**STAFF REPORT**  
**COMMUNITY DEVELOPMENT DEPARTMENT**

DATE: 3/17/2026  
TO: City Council  
FROM: Sonya Allen, Associate Planner  
208-884-5533  
[sallen@meridiancity.org](mailto:sallen@meridiancity.org)  
SUBJECT: FP-2025-0013  
Burnside Ridge Estates No. 1

Final plat consisting of 52 buildable lots and 15 common/other lots on 26.26 acres of land in the R-4 and R-8 zoning districts for the first phase of Burnside Ridge Subdivision.

D. Common Driveway Exhibit

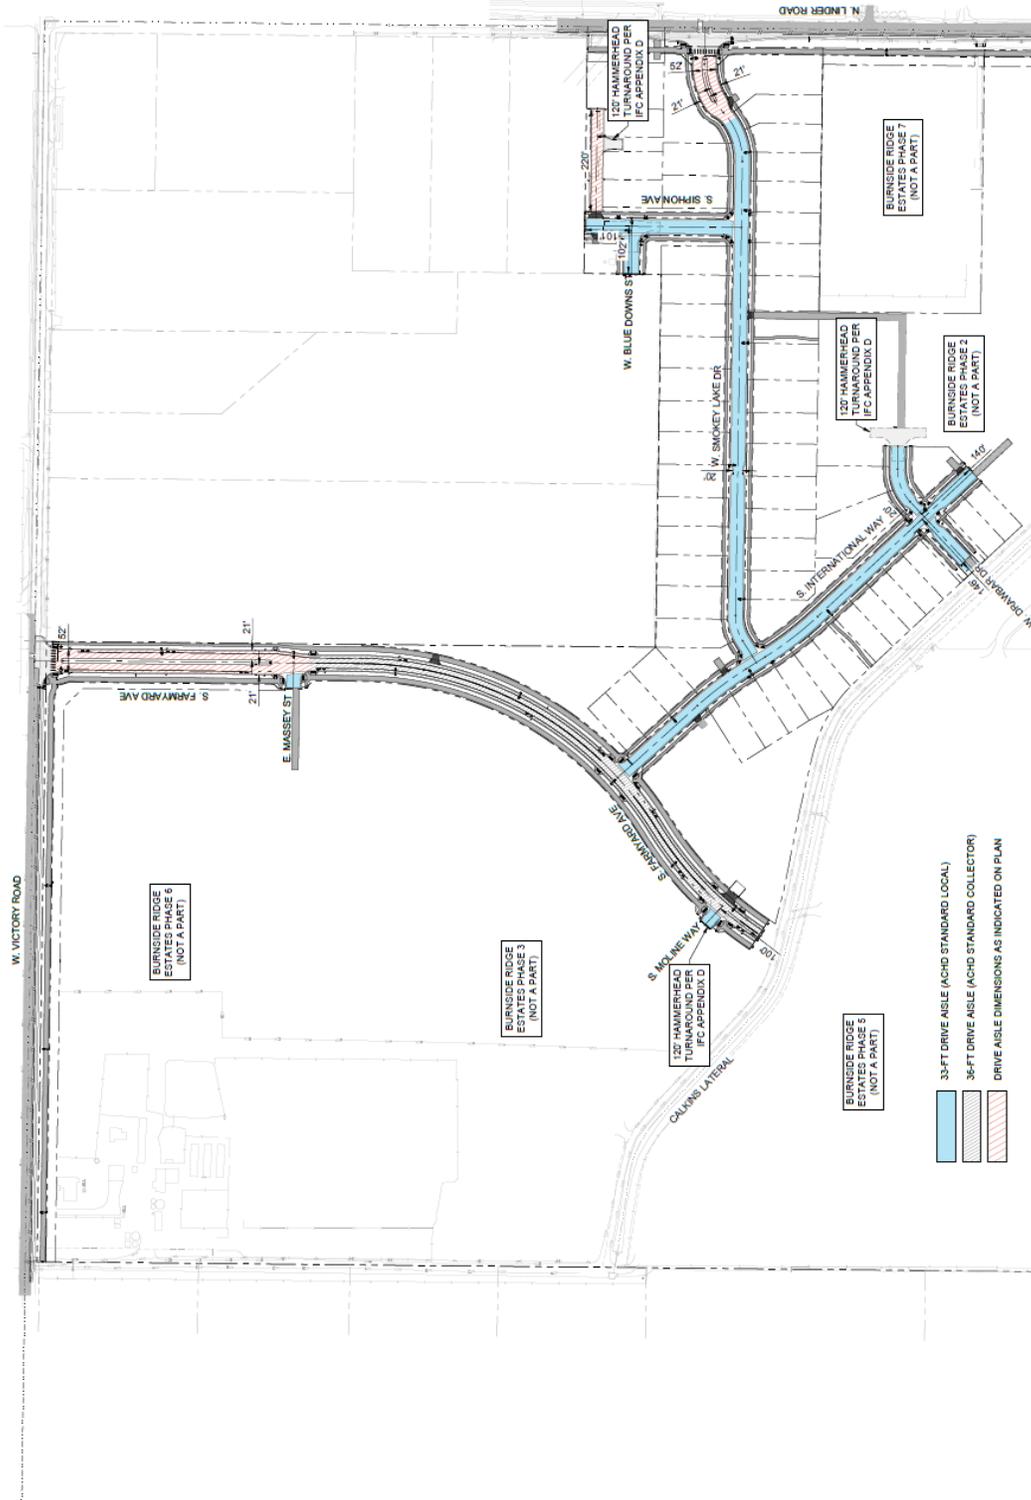
A modification to the street layout at the northeast corner of the development, within Blocks 1 and 2, is proposed due to the presence of an existing cell tower and associated easement located on Lot 2, Block 2, which was not identified at the time of the preliminary plat. As a result, the

stub street extending to the west – W. Blue Downs Street (labeled as E. Guernsey Street on the preliminary plat) – has been shifted further south. A stub street to the north is proposed with a common driveway for access to Lots 2, 3, 5, and 8, Block 1.

The proposed common driveway serves four (4) homes – three (3) homes on the south side of the driveway and one (1) at the end of the driveway. The proposed driveway will be located 5 feet south of the northern property line, future development to the north will not be able to use the driveway, ensuring future use is limited to four (4) homes in accord with UDC 11-6C-3D.1.

Staff discussed the proposed stub street locations with ACHD and they indicated a preference for the stub street to be oriented to the west rather than to the north, citing greater development potential for the property to the west. The adjacent property to the north is constrained by the Northwest gas pipeline easement, which limits development opportunities as access over the pipeline is limited. Because that property only has access via Linder Rd., an arterial street, UDC 11-3A-3A.3 requires local street access to be provided to that property. For this reason and because right-of-way (ROW) was proposed to the north boundary with the preliminary plat, Staff requested a stub street be provided to the north as proposed.

10. Future development of Lots 2, 3, 5 and 8, Block 1 shall be consistent with the common driveway exhibit included in Section V.D and the standards listed in UDC 11-6C-3D.
